COMMUNICATION EQUIPMENT MAINTENANCE BULLETIN

SECTION 9. TRANSMITTING EQUIPMENT

FIGURE 1.—Revision for models TBA-3, -6, and -10.

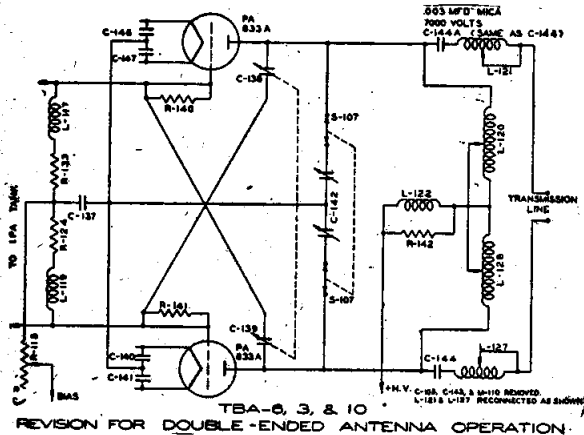
Procedure.—Revise the circuit as shown in Figure 1 to provide satisfactory loading into a 600-ohm transmission line.

FIGURE 1.—Revision for model TBA-2.

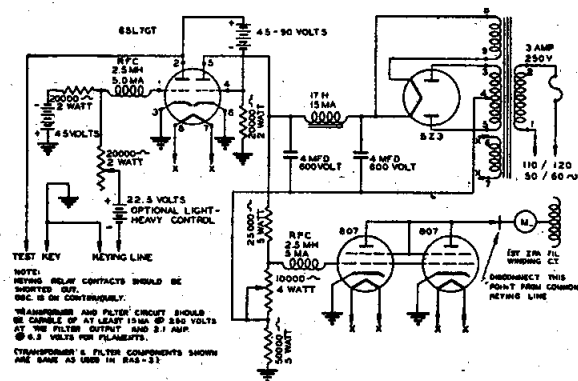
Procedure.—Revise circuit as shown in Figure 1 for high speed keying of the TBA-2.

FIGURE 2.—Revision for model TBA-6.

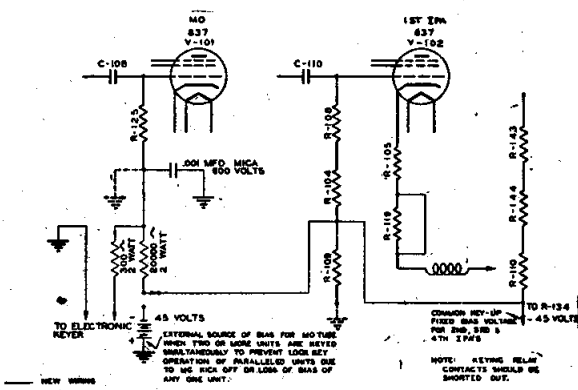
Modification of the TBA-6 for high speed keying is shown in Figure 2.

FIGURE 1.—Modification of the O-5/FR exciter unit to permit its use with the master-oscillators of the TBA, TBK and TBM series transmitters

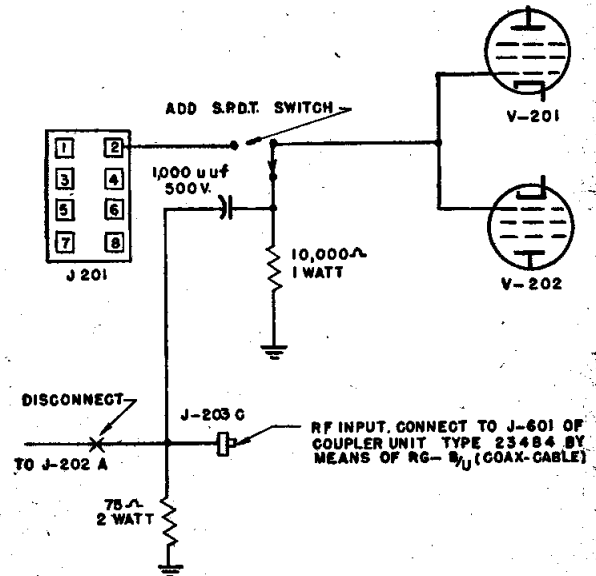
Procedure.—Modify the O-5/FR exciter unit as shown in Figure 1 (drawing RE67A107).

FIGURE 1.—Schematic of the cathode modulator for the TBK.

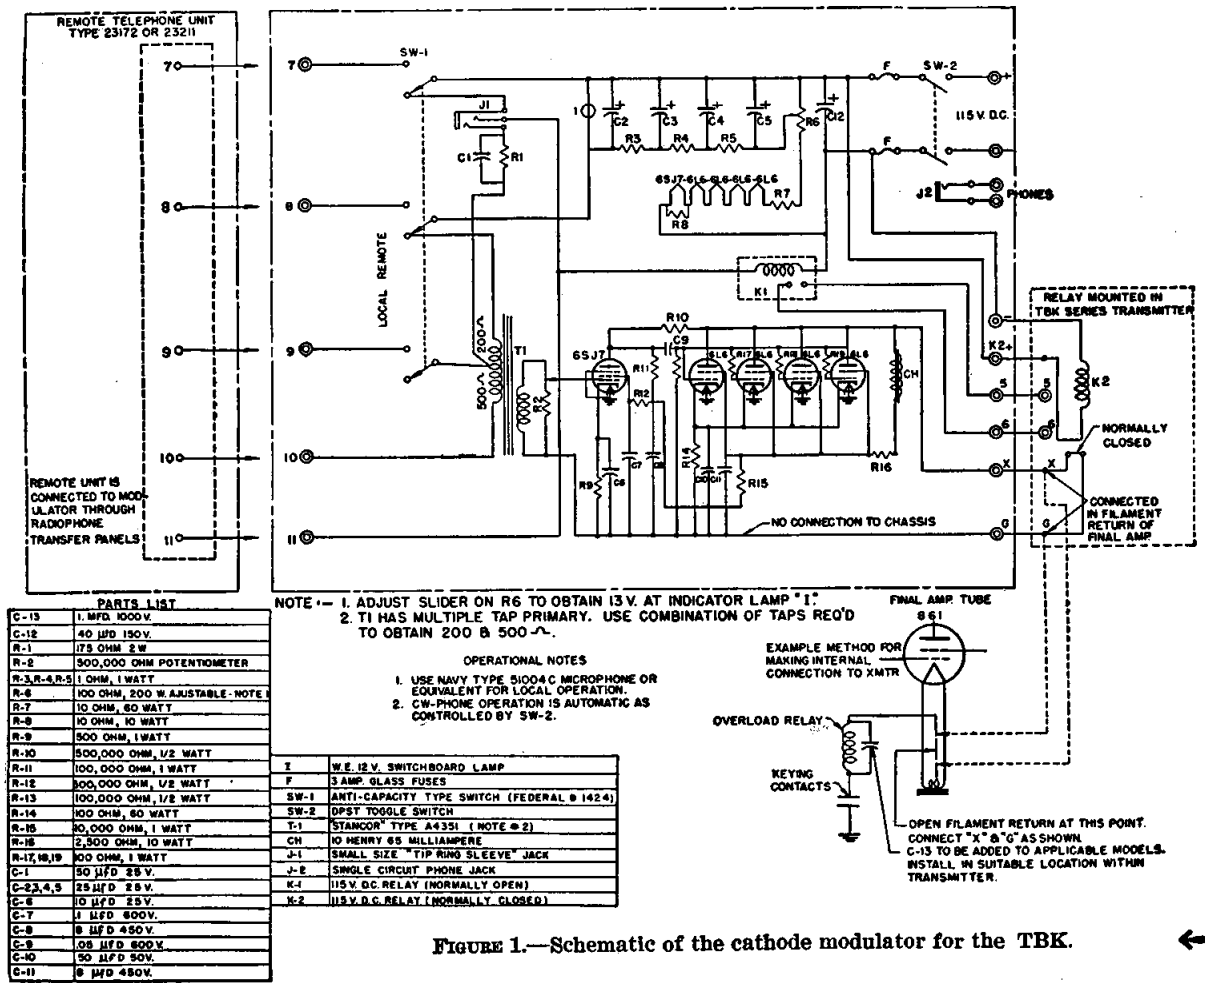
The circuit diagram of the model TBK cathode modulator, Figure 1 on page TBK:3, Supplement No. 8 of the C. E. M. B., incorrectly showed the choke (CH) next to the final 6L6 as being short-circuited. With supplement No. 20 there has been included a new page TBK:3 with Figure 1 shown in its corrected form. 10/1/47 ←

FIGURE 1.—Modification of the O-5/FR exciter unit to permit its use with the master-oscillators of the TBA, TBK and TBM series transmitters.

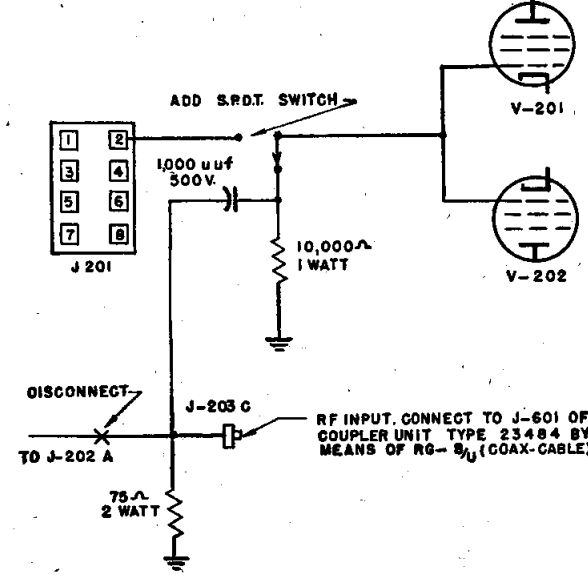
Procedure.—Modify the O-5/FR exciter unit as shown in Figure 1 (drawing RE67A107).

FIGURE 1.—Modification to provide stand-by circuit.

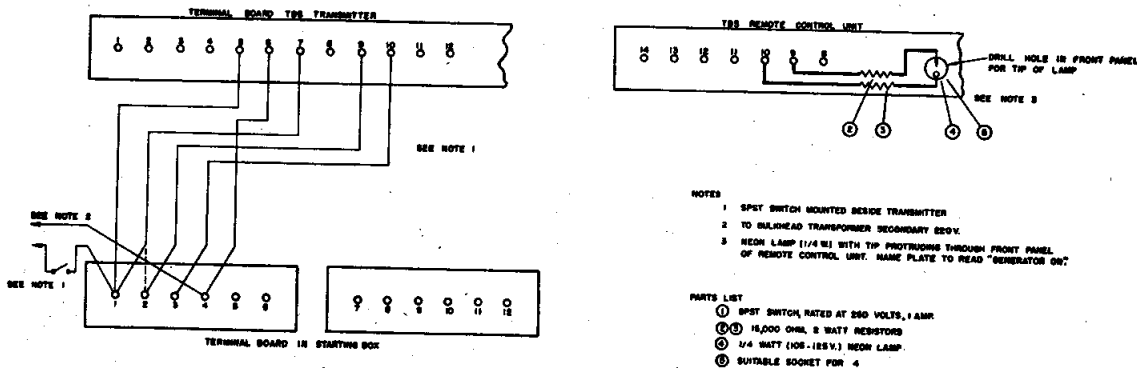
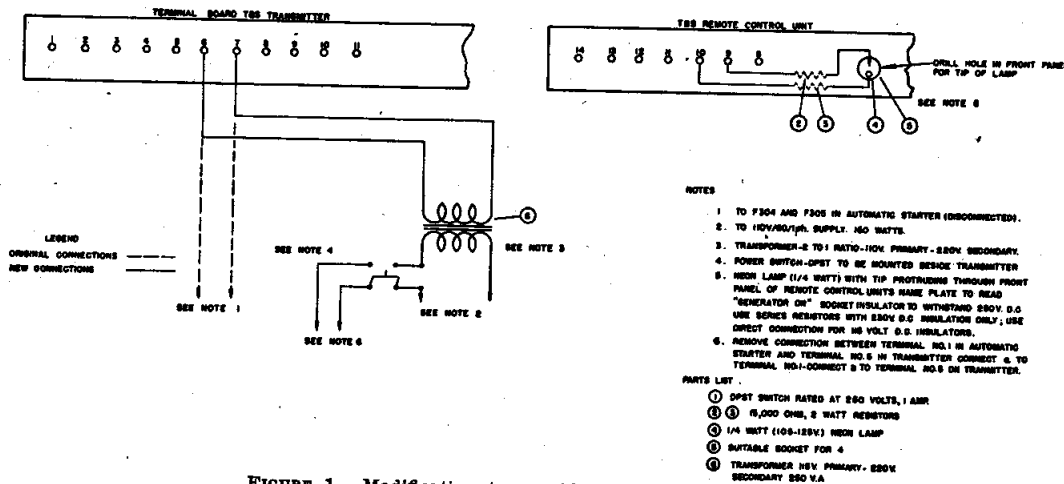
Equipments affected.—All model TBS through TBS-6 series transmitting equipments.
Purpose.—To provide a stand-by condition whereby the tube filaments are energized and the warm-up period eliminated.

Procedure.—(This change should be accomplished as shown in Figure 1.)

FIGURE 1.—Modification to improve the reliability of relay K-101 in the TBS equipments.

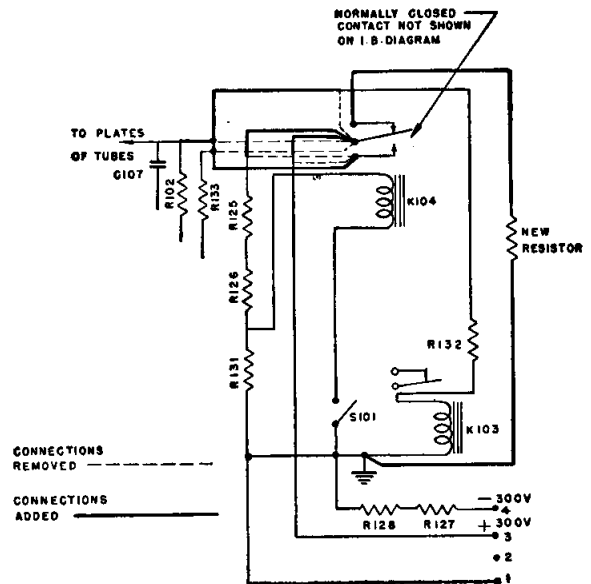
Purpose.—To improve the reliability of relay K-101.

Procedure.—Referring to Figure 1, the modification is made as follows:

FIGURE 2.—Revised output circuit.

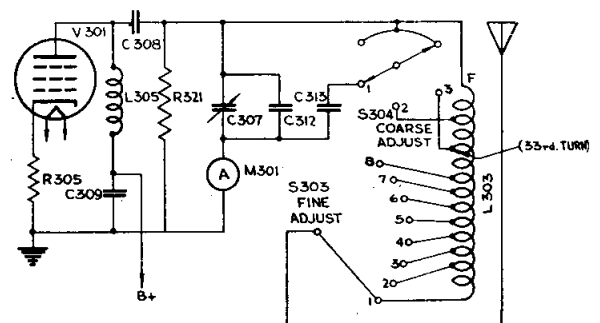
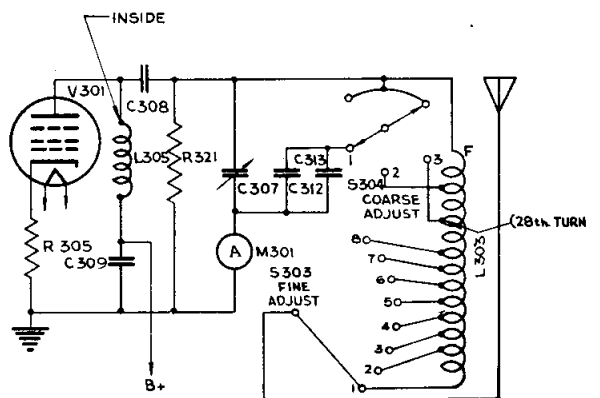
(2) The following steps are illustrated in Figures 1, 2, 3 and 4.

FIGURE 1.—Revision for TCC-3 equipments.

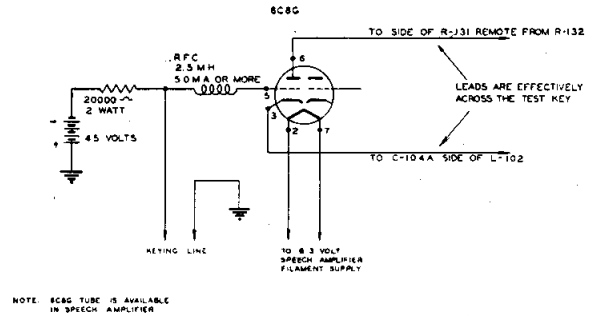
The high speed keying circuit of Figure 1 is not intended for general use and should be used only in those instances where high speed keying or parallel high speed keying of TCC transmitters is necessary. No standard Navy type units which will provide similar operation are available at this time.

FIGURE 1.—Plan of modification.

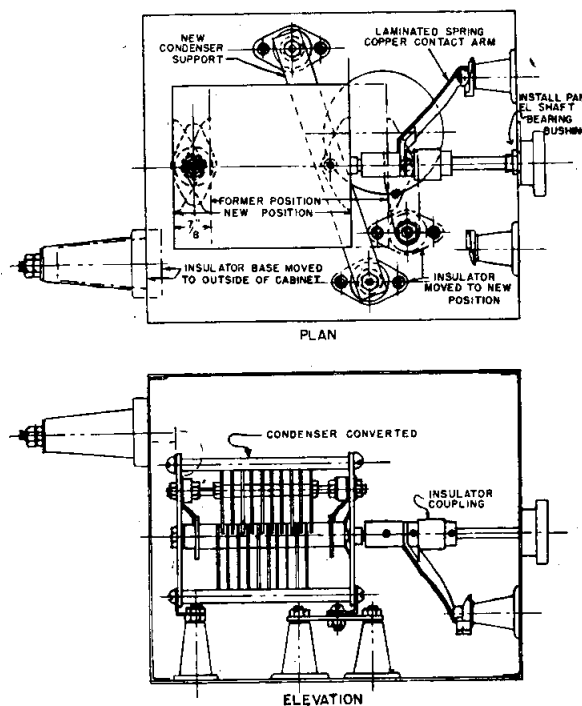
Field activities experiencing installation and operation difficulties similar to those listed above should modify the unit in accordance with the following procedure which has been developed and successfully employed by the Puget Sound Navy Yard. (See Figure 1):

FIGURE 1.—Modification of relay K-101.

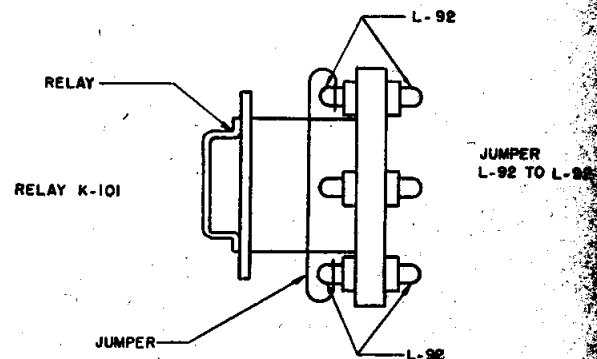
Procedure.—Place the jumper as indicated in Figure 1, from L-92 to L-92.

FIGURE 1.—Damaged tap switch.

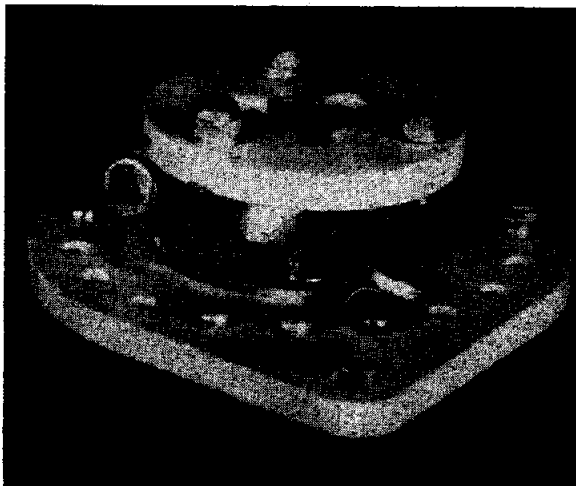
The nature of the failure is that the spring mounted moving contact falls below the surface level of the fixed contact, and the spring action usually causes it to rest on the ceramic mounting plate. If a sudden or great force is exerted while the moving contact is in this position, the moving contact may be bent out of shape or broken off as shown in Figure 1.

Add sections of phenolic insulation (equal in thickness to the distance from the top of the fixed contact to the surface of the ceramic plate) to the ceramic plate, as shown in Figure 2.

FIGURE 1.—Schematic diagram showing completed and correct changes to incorporate noise limiter adapter unit.

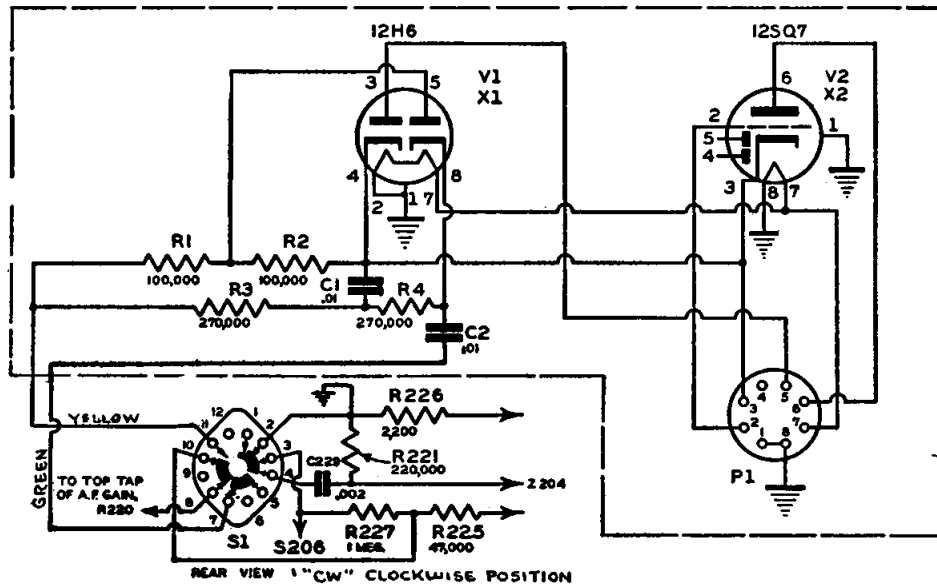
4. In the position formerly occupied by switch S-205 mount the new rotary switch S-1, with the colored locating spot up. Place the switch plate A-2 in position on the front of the panel, then firmly attach both switches and plate to the panel. Solder the brown tracer wire (taken from switch S-203) to lug No. 3 on switch S-1. See schematic diagram figure 1, which portrays the rear view of the switch, in order to identify the lugs, since the numbers are not stamped on. Solder the white wire to lug No. 2, and solder the red-and-green tracer wire to lug No. 4 on switch S-1. Unsolder the orange tracer wire from the top tap of the audio gain control R-220, and solder it to lug No. 10 on S-1. Connect and solder the bare wire from lug No. 8 on S-1 to the top tap of the R-220 control. Remove the center screw, and lock the washer in the plate of the r-f chassis directly opposite the center of the socket X-206.

5. Replace the 12A6 tube (V-207) in its socket (X-207), and plug the Noise Limiter Adapter Unit into the socket X-207. See figure 1.
